APPEAL SUMMARY

Appeal ID: 20203	Project Address: 1525 N Webster St
Hearing Date: 4/10/19	Appellant Name: Sergey Marandyuk
Case No.: B-004	Appellant Phone: 9713223318
Appeal Type: Building	Plans Examiner/Inspector: Elgin Rowland
Project Type: commercial	Stories: 3 Occupancy: R-2 Construction Type: V-A
Building/Business Name: Webster Apartments	Fire Sprinklers: Yes - Entire Building
Appeal Involves: Erection of a new structure	LUR or Permit Application No.: 16-250748-CO
Plan Submitted Option: pdf [File 1] [File 2] [File 3] Proposed use: Multi-family Residential

Appeal item 1

1525 N Webster Street
Webster Street
Apartments
Portland, OR

g. LATCH APPROACH, PUSH SIDE

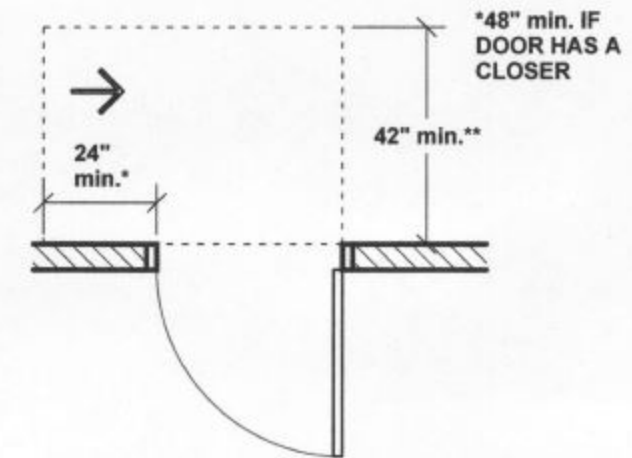
Requires "Latch Approach, Push Side" requires a minimum of 24" clearance on the Latch Side. This scenario also assumes there is a minimum width of 42" for the walkway.

Proposed Design Since our walkway (56" in width) is bigger than the minimum requirement (42"), we believe the extra width in the walkway should be considered in determining the clearance required for a "Latch Approach, Push Side". Looking at the "Front Approach Push Side" it only requires 12" clearance on the side of the door with a minimum of 48"x48" floor area box. We believe our 56" wide walkway with only 12 inches of clearance of the side of the door would allow plenty of room to operate.

Maneuvering space at entry door to Type A dwelling unit: Granted as proposed.

1 GROUND LEVEL PLAN

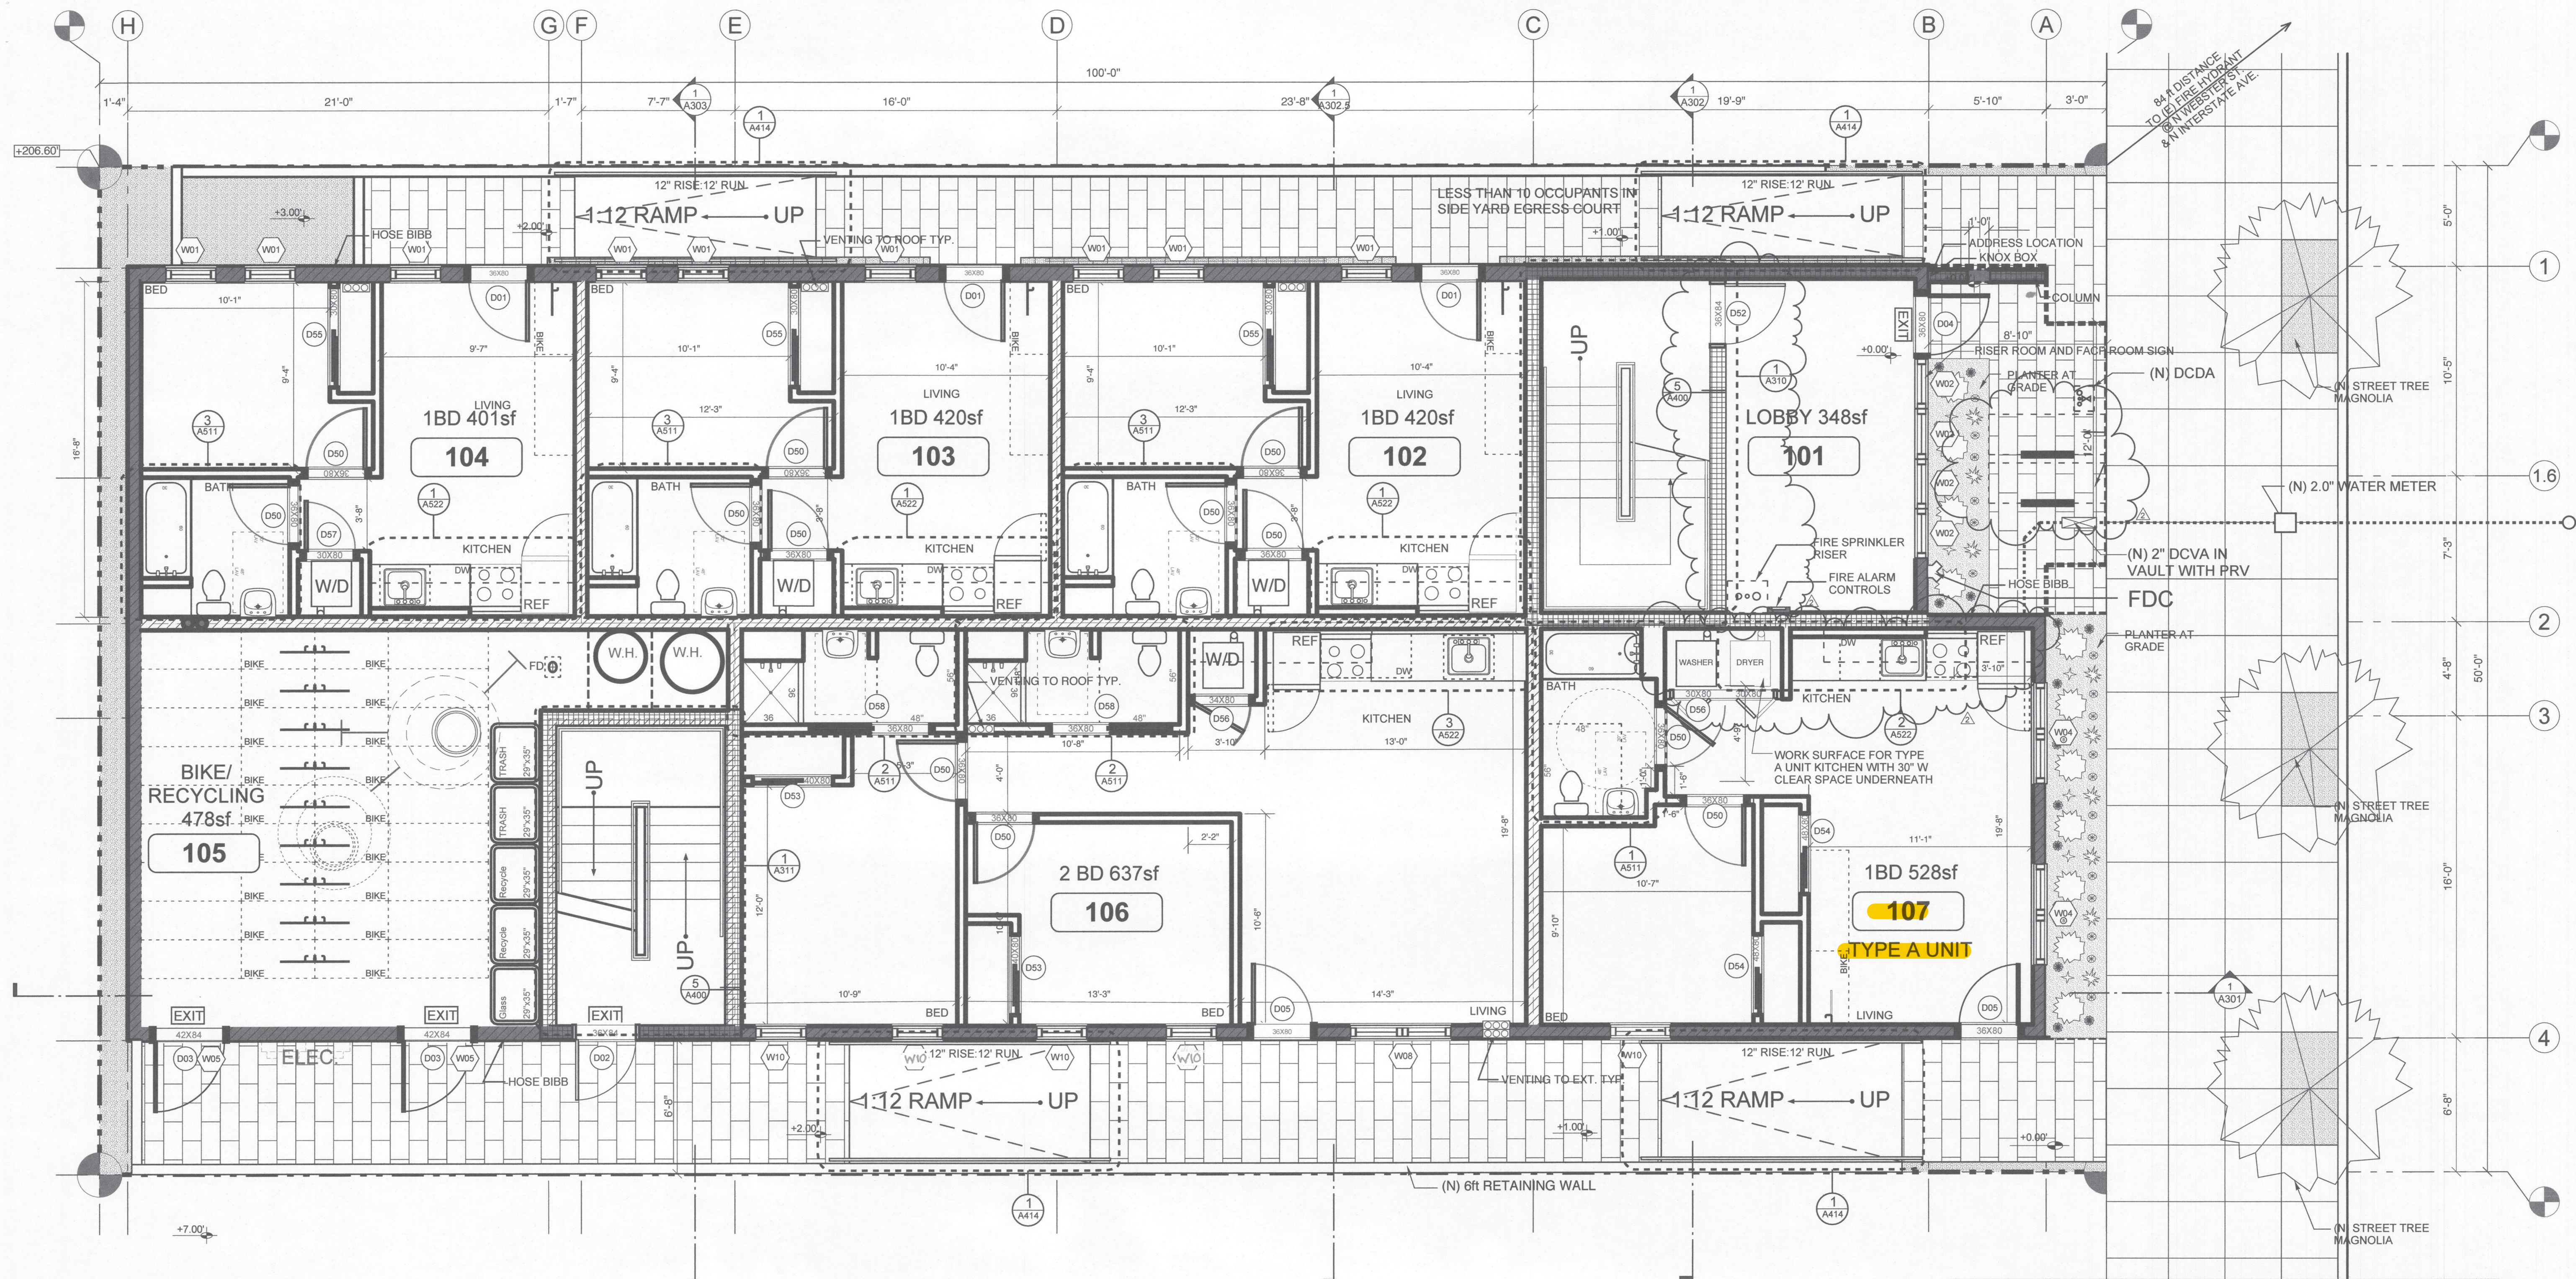
Additionally, this is a corner unit, so coming from the hinge side there is plenty of clearance since it is an outside corner, to the front of the building. We think it would be easy to turn or make any kind of maneuvering act right outside the unit if necessary.

Due to the electrical meters (which cannot be moved) installed next to unit 107, there is only 12" clearance on the side of the entry door of the unit. Since this unit is Type A, we are required to have a minimum of 24" clearance. We are short of the requirement by 12 inches.

Note: This does not waive any federal requirements for accessibility that are enforced by Department of Justice.
